DEVELOPMENT ASSESSMENT REPORT	
<b>Application No.</b>	D/2019/321
<b>Address</b>	140-142 Norton Street LEICHHARDT NSW 2040
<b>Proposal</b>	Part demolition and alterations and additions to existing building to provide for a part three and part four storey mixed use building comprising commercial tenancy to Norton Street and eight units, with lower ground / basement level accommodating parking accessed via the rear lane
<b>Date of Lodgement</b>	22 August 2019
<b>Applicant</b>	Lamton P/L C/O Design Delta Architects
<b>Owner</b>	Lamton Pty Ltd
<b>Number of Submissions</b>	6 submissions from 3 properties
<b>Value of works</b>	\$2,476,811.00
<b>Reason for determination at Planning Panel</b>	Development to which <i>State Environmental Planning Policy No 65</i> applies and is 4 storeys in height
<b>Main Issues</b>	Internal Amenity; Parking and Access; and Visual Privacy
<b>Recommendation</b>	Deferred Commencement Approval

<b>Attachment A</b>	Recommended conditions of consent
<b>Attachment B</b>	Plans of proposed development

Date Issued: 10/12/19  
Scale: 1:200 @ A3  
Job No: 1811  
Sheet #: A54

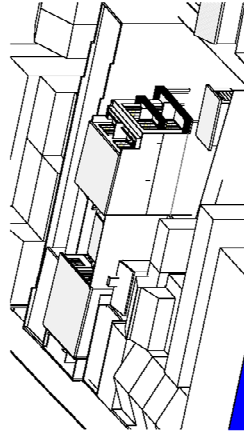
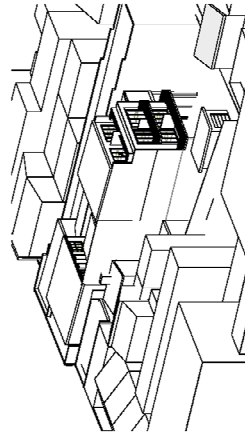
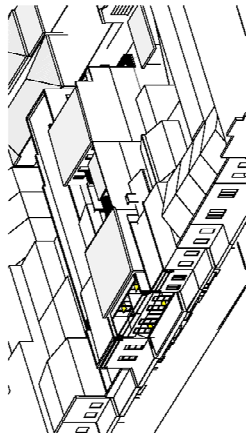
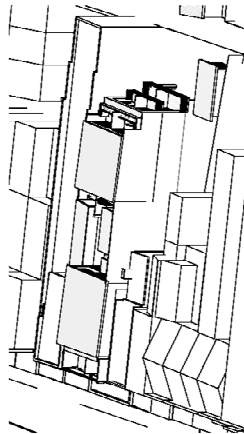
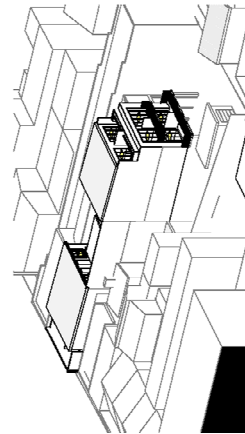
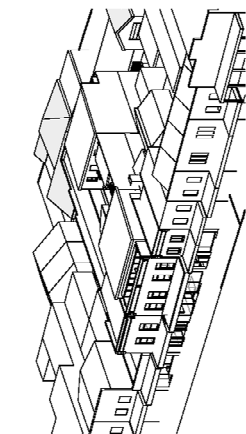
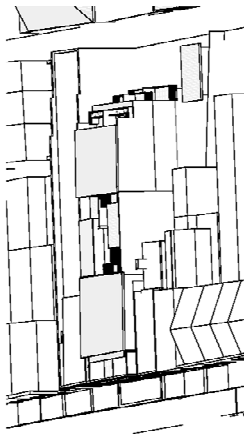
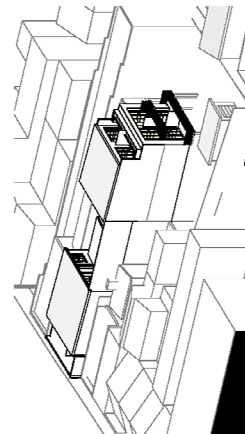
**Comment:** The proposed communal open space on Level 1 is approximately 72m<sup>2</sup> in size, which is approximately 17.3% of the site area. The shadow diagrams and sun study provided indicate that the communal open space will not receive a minimum of 2 hours solar access to 50% of the communal open space area between 9am and 3pm during winter solstice. Having considered the constraints of the proposed site and the nature of the proposal as a mixed use development where it is not possible to utilise the ground floor level for communal open space, and given the private open space areas for each unit exceed minimum requirements and excellent proximity to local recreational areas, services and facilities within walking distance, it is considered that a variation to the communal open space requirement is acceptable in this instance.
